ARCHITECTURAL REVIEW BOARD MEETING
CITY HALL, 385 SOUTH GOLIAD STREET, ROCKWALL, TEXAS
AUGUST 15, 2023 IN THE CITY COUNCIL CONFERENCE ROOM AT 5:00 PM

CITY OF ROCKWALL
PLANNING AND ZONING COMMISSION CASE MEMO

TO: Planning and Zoning Commission
DATE: August 15, 2023
APPLICANT: Hind Saad; RSG Engineering
CASE NUMBER: SP2023-022; *Site Plan for 1760 Airport Road*

TO: Planning and Zoning Commission
DATE: August 15, 2023
APPLICANT: David Lindsey; *Tri-Tex Construction, Inc.*
CASE NUMBER: SP2023-024; *Site Plan for 955 Sids Road*

PROJECT No: SHEET No:
23420.02 A2.0

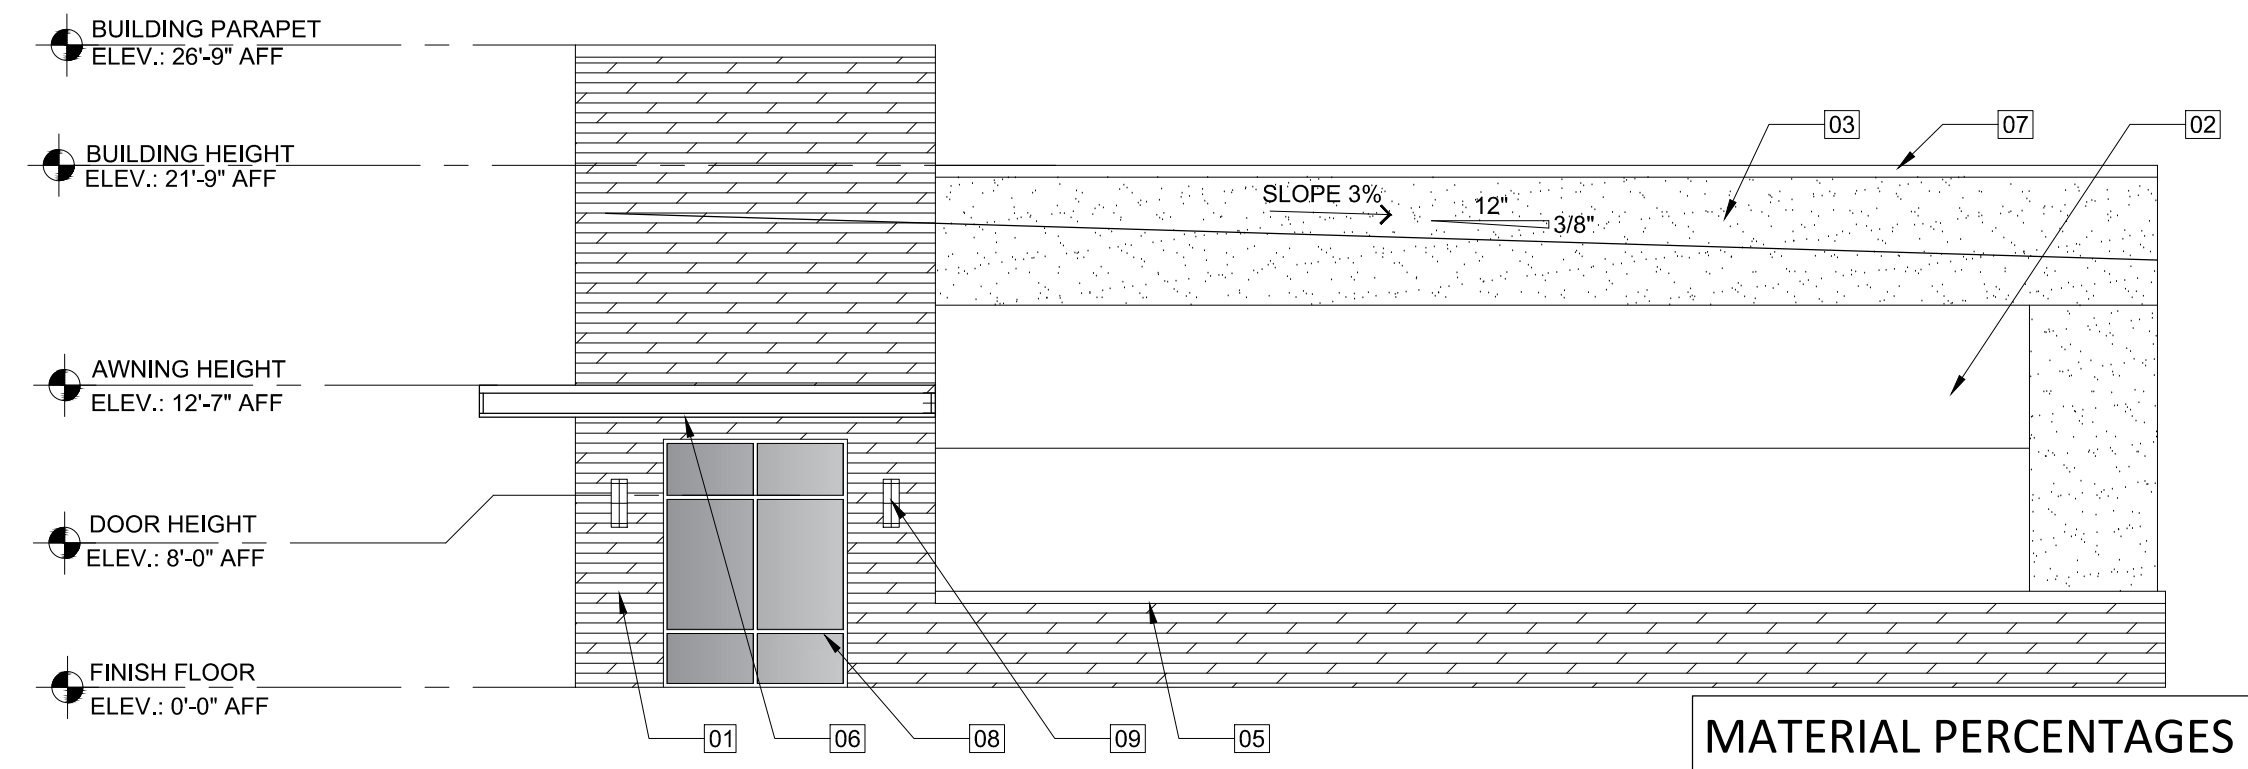
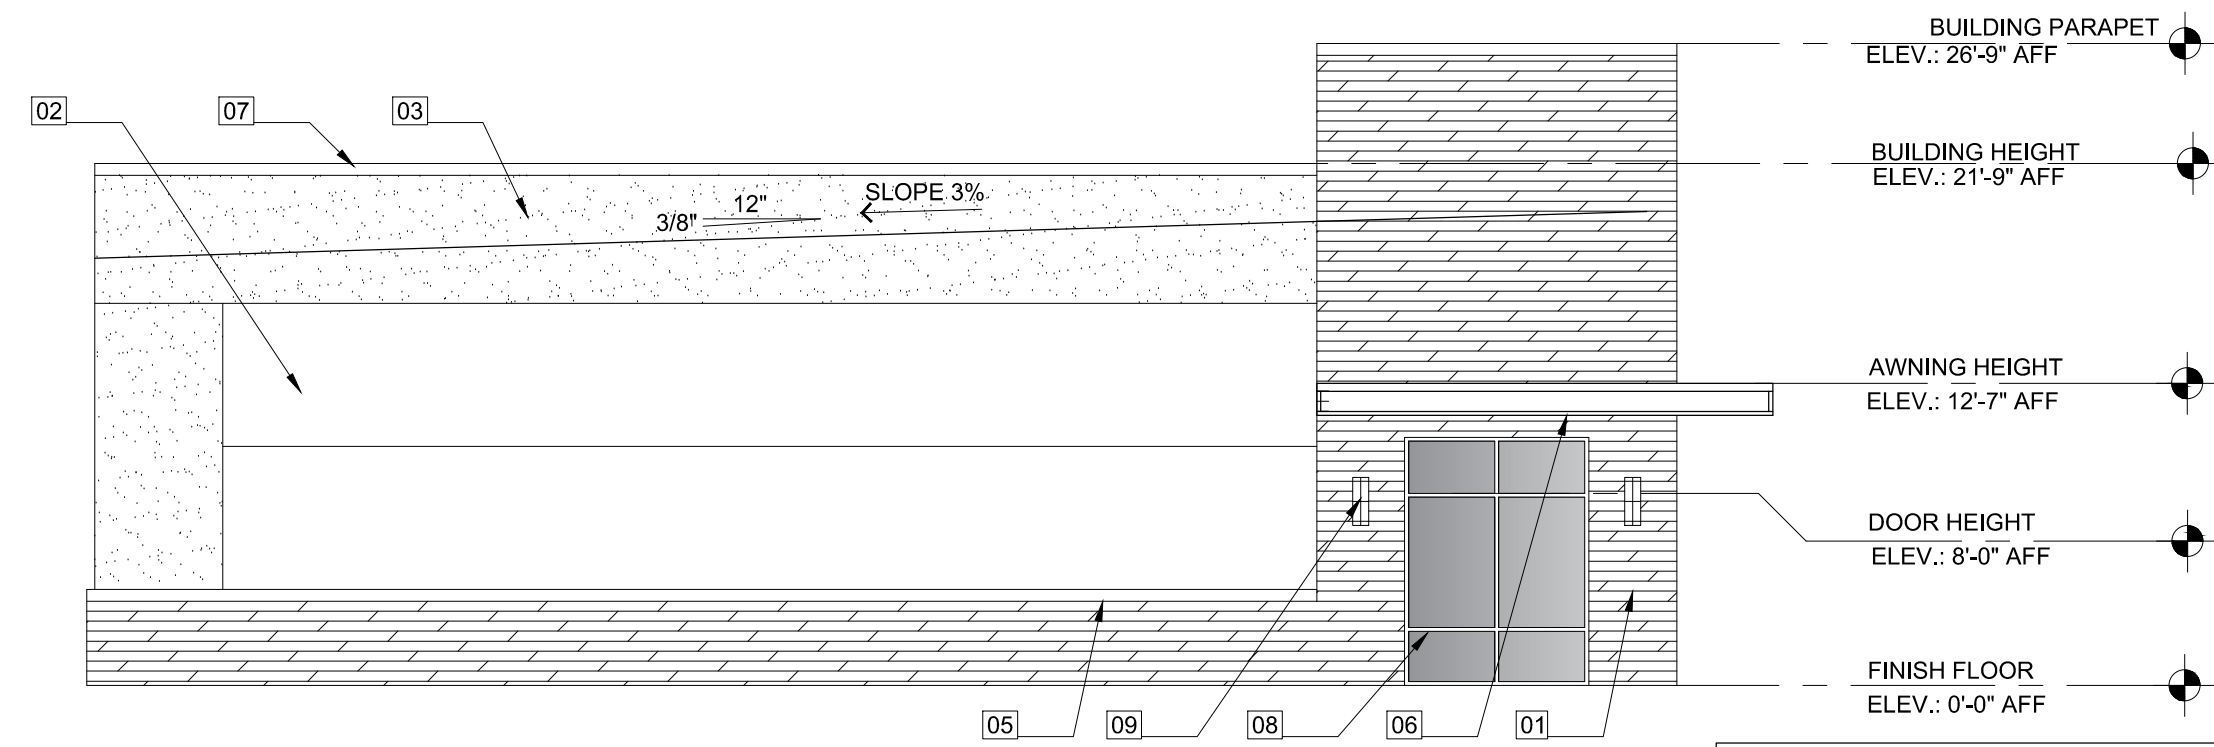
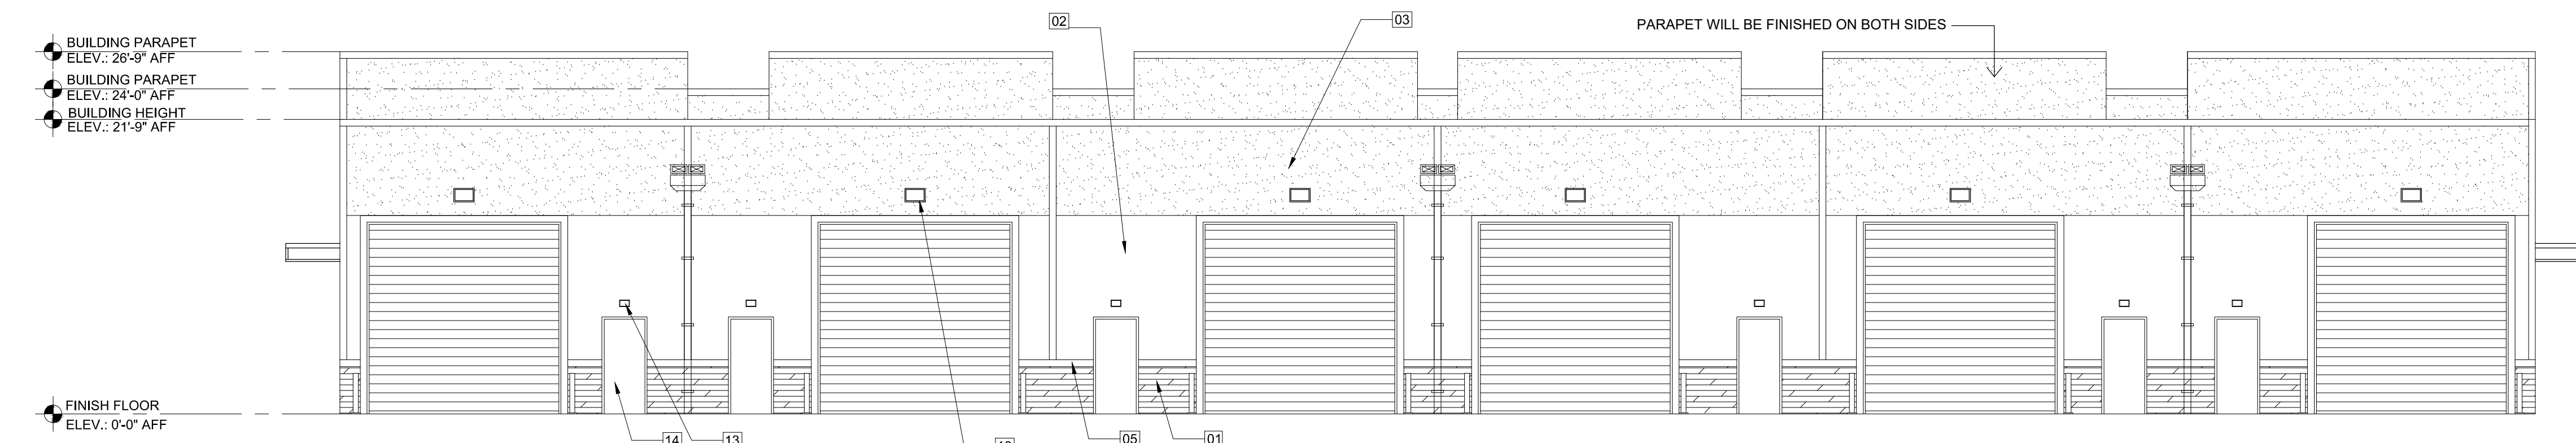
- (a) *Stone*. According to Subsection 05.01 (A)(1), *Materials and Masonry Composition*, of Article 05, *District Development Standards*, of the Unified Development Code (UDC), a "...minimum of 20% stone (*i.e. natural or synthetic/cultured*) is required on all building façades." In this case, the applicant is proposing 20% stone on all buildings except for the rear elevations of buildings 2-7. This will require an exception from the Planning and Zoning Commission.

- (b) *Primary Materials*. According to Subsection 05.01 (A)(1), *Materials and Masonry Composition*, of Article 05, *District Development Standards*, of the Unified Development Code (UDC), "(e)ach exterior wall of a building's façade shall consist of a minimum of 90% Primary Materials..." or masonry material. The applicant is proposing mostly metal buildings. This will require an exception from the Planning and Zoning Commission.

On July 25, 2023, the Architecture Review Board reviewed the proposed building elevations provided by the applicant on July 14, 2023 and recommended that the applicant conform closer to the Light Industrial standards of the UDC, provide parapets

on all four sides, and provide samples of the stone proposed. The applicant has provided updated elevations that will be reviewed by the Architectural Review Board (ARB) prior to the August 15, 2023 Planning and Zoning Commission meeting.

EXTERIOR MATERIALS:	
SOFFIT:	METAL
SIDING:	R PANEL, BEIGE
STONE:	36" PONY WALL, OKLAHOMA STONE
ROOF:	STANDING SEAM, BLACK
PORCH POSTS:	8" CEDAR, ROUGH SAWN
POST BASES (IF APPLICABLE):	18"X18"X48", OKLAHOMA STONE
CORNER TRIM:	YES
GUTTERS: YES	
(SEE STYLE SHEET FOR ADDITIONAL INFO.)

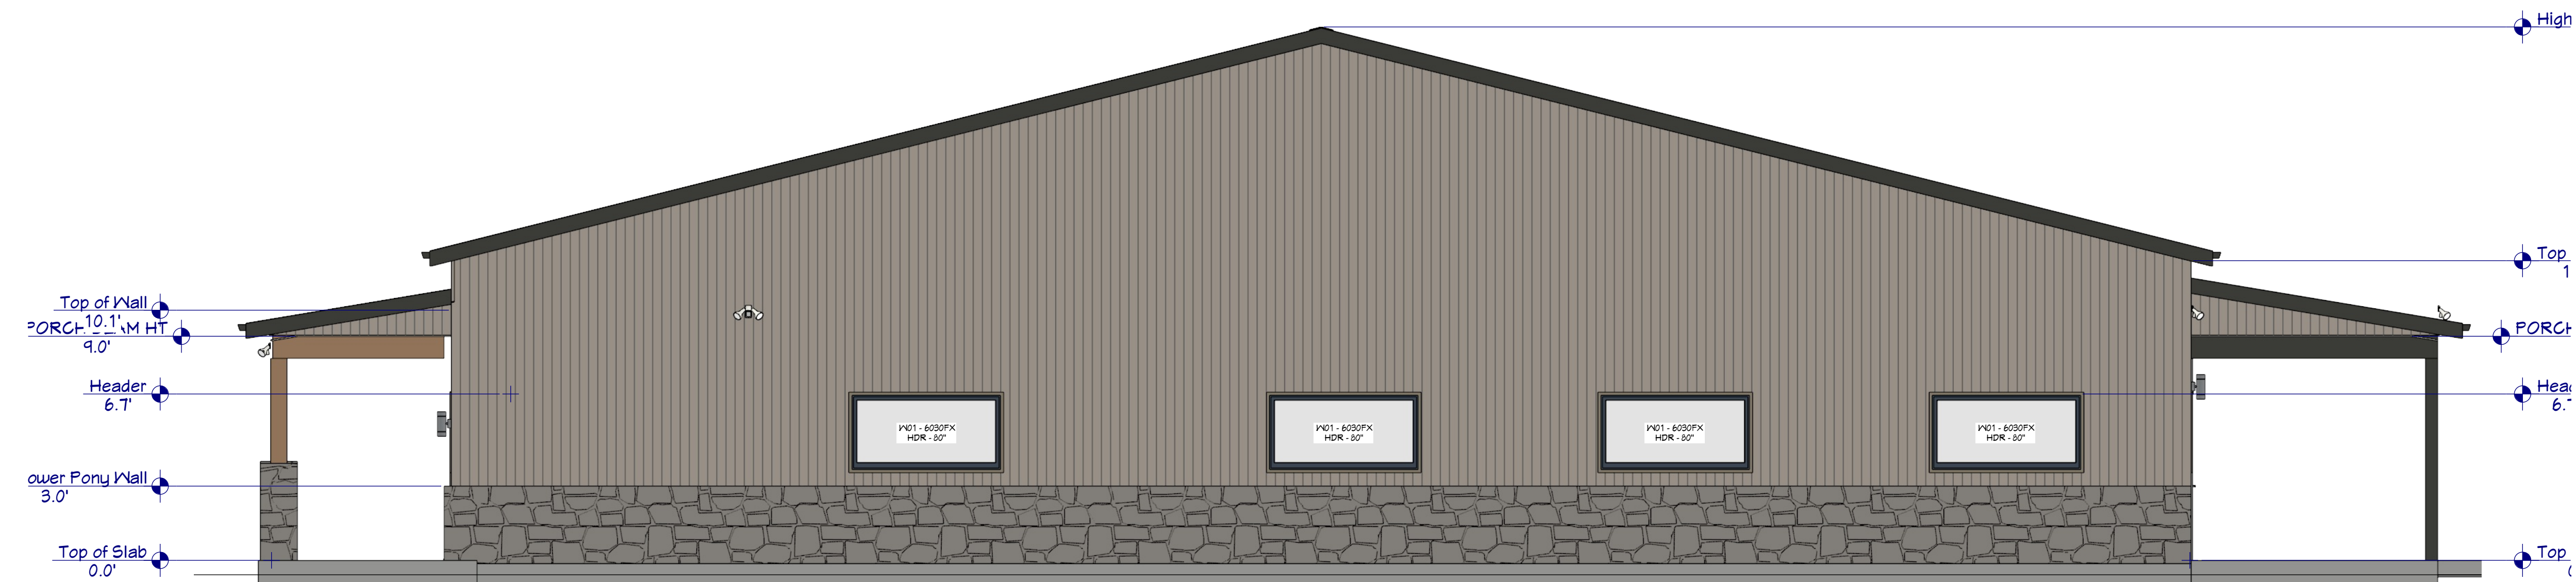
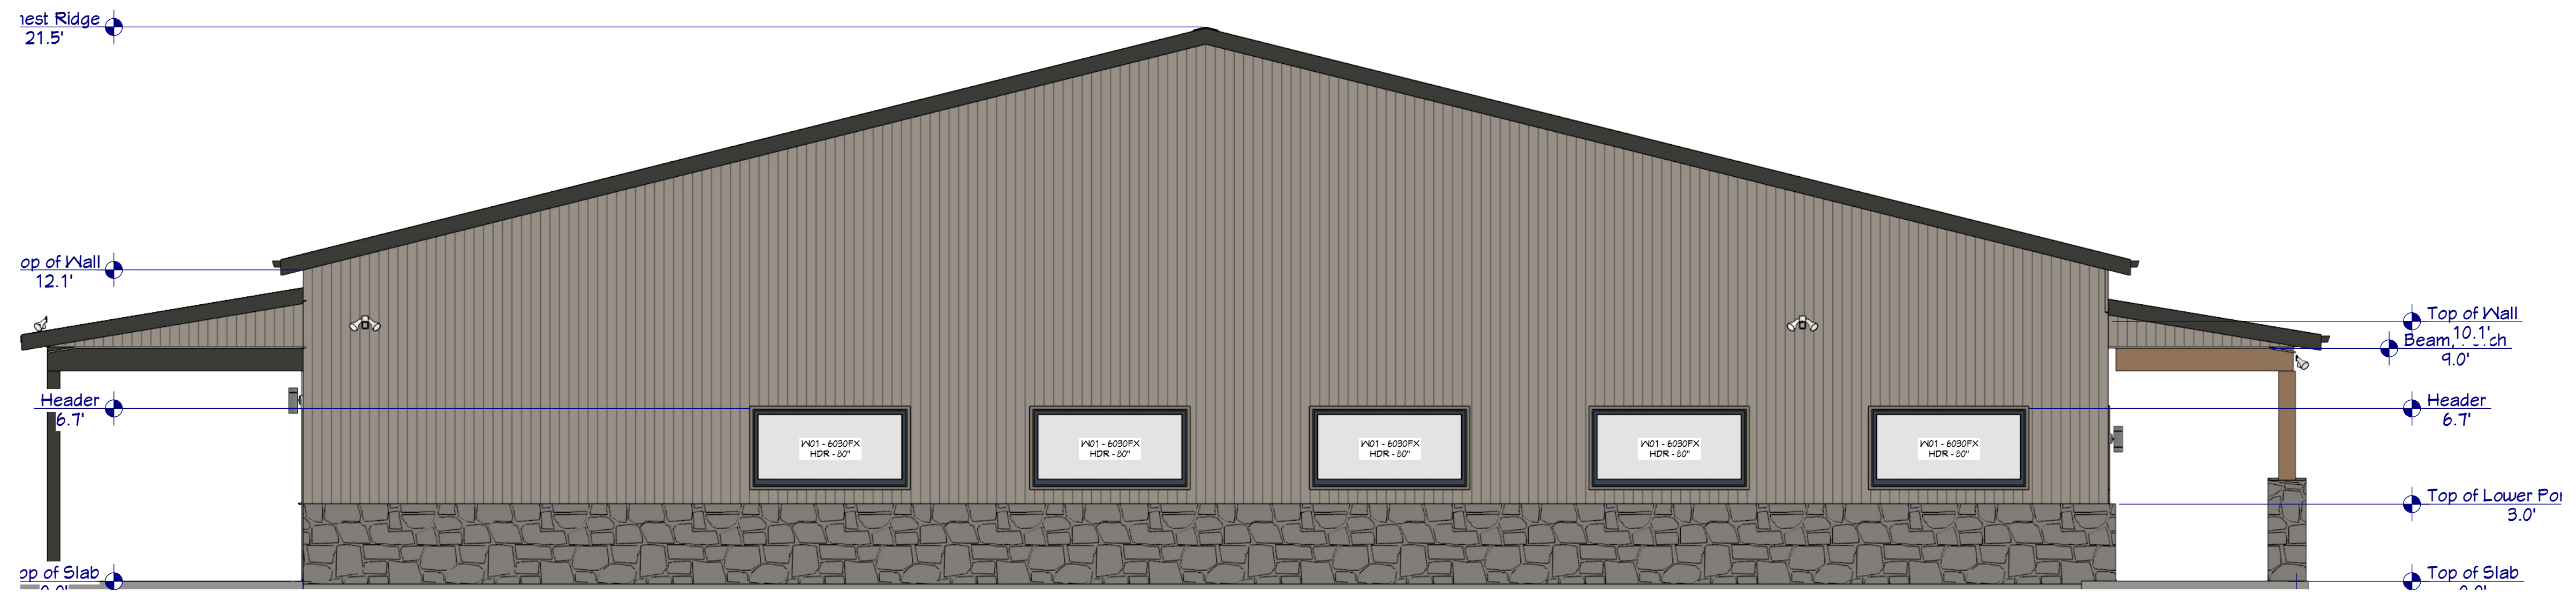
- (a) Primary and Secondary Building Facades. According to Subsection 04.01 (C), *General Commercial District Standards*, of Article 05, *District Development Standards*, of the Unified Development Code (UDC), for primary and secondary building facades a "... wall length shall not exceed three (3) times the wall height." In this case, the new building the applicant is proposing does not meet the wall length requirement. This will require an exception from the Planning and Zoning Commission.

On July 25, 2023, the Architectural Review Board (ARB) reviewed the proposed building elevations. The ARB made the recommendation to the applicant to wrap the stone wainscot around the sides of the building, except for the rear of the building. Before the ARB takes action, they want to see the revised building elevations at the August 15, 2023 ARB meeting.

Revision Table			
Label	Date	Revised By	Description
REV 01	4/3/2023	AJH	BID/REVIEW PLANS
REV 02	8/8/2023	AJH	EXTENDED MAINSCOT, GENERAL NOTE UPDATES, SITE PLAN/LANDSCAPE UPDATES
